SUBDIVISION REVIEW SHEET**CASE NO.:** C8-2018-0175.0A**P.C. DATE:** December 10, 2019**SUBDIVISION NAME:** Cartwright Lots, Resubdivision of Part of Lot 32, Theodore Low Heights Subdivision**AREA:** 0.99 acres**LOTS:** 4**APPLICANT:** 3204 Clawson LLC
(Brett Hatton)**AGENT:** Servant Engineering &
Consulting (Mauricio Quintero-
Rangel)**ADDRESS OF SUBDIVISION:** 3204 Clawson Road**GRIDS:** G-19**COUNTY:** Travis**WATERSHED:** West Bouldin Creek**JURISDICTION:** Full Purpose**EXISTING ZONING:** SF-3**DISTRICT:** 5**PROPOSED LAND USE:** Single Family**NEIGHBORHOOD PLAN:** South Lamar Combined (suspended)**SIDEWALKS:** Sidewalks will be installed on Clawson Road.**VARIANCE:** From 25-4-175, Land Development Code (LDC) to allow for flag lot. (See attached)**DEPARTMENT COMMENTS:** The request is for approval of a flag lot variance and resubdivision namely, Cartwright Lots, Resubdivision of Part of Lot 32, Theodore Low Heights Subdivision. The proposed resubdivision consists 4 lots on 0.99 acres.**STAFF RECOMMENDATION:** Staff recommends approval of the variance and resubdivision. With approval of the variance - this plat will meet all current applicable City of Austin Land Development a

3204 Clawson Comparable Development

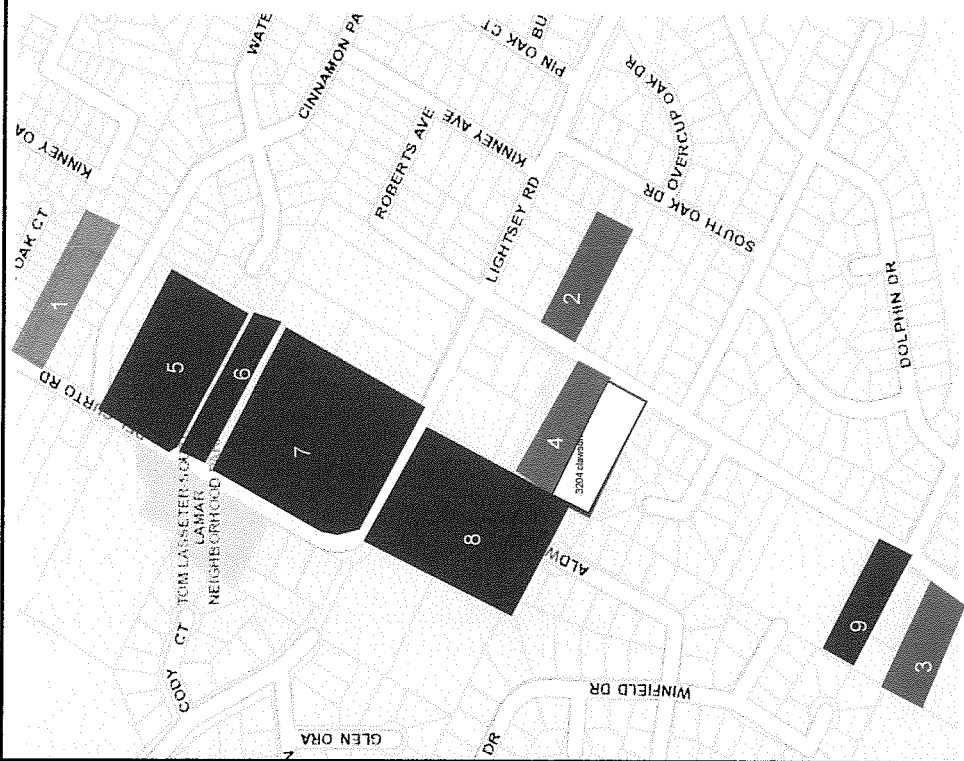
The adjacent property located at 3202 Clawson has been resubdivided into 4 flag lots. The lots across the street from this proposed resubdivision, located at approximately 3115 Clawson Road, have been resubdivided into 4 flag lots. There are several other flag lot resubdivisions in the nearby vicinity of this proposed flag lot resubdivision as shown on the attached Neighborhood exhibit. The immediate area is zoned SF-3 which is the appropriate zoning for the proposed use.

- INDEX
- DRIVEWAY & UTILITY / CONCEPTUAL PLAN
 - CONCEPTUAL WASTEWATER PLAN & PROFILE

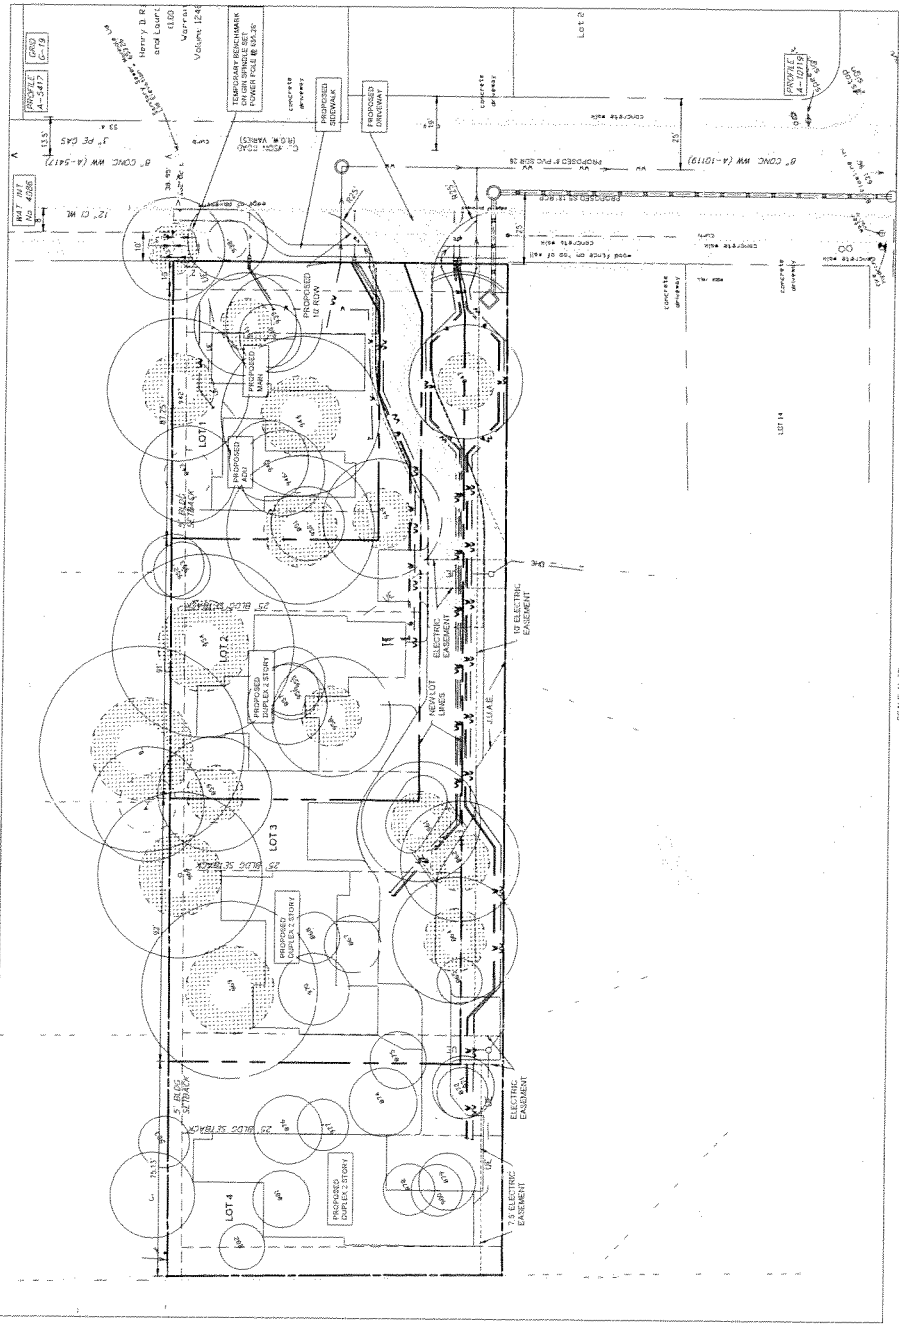
The applicant has provided a driveway and utility plan to reviewers for the City of Austin Water and Wastewater review and Austin Energy Departments. The reviewers have determined after review of the utility/driveway plan that there is adequate room to provide utility service to both lots and utilities will not cross the proposed new lot lines.
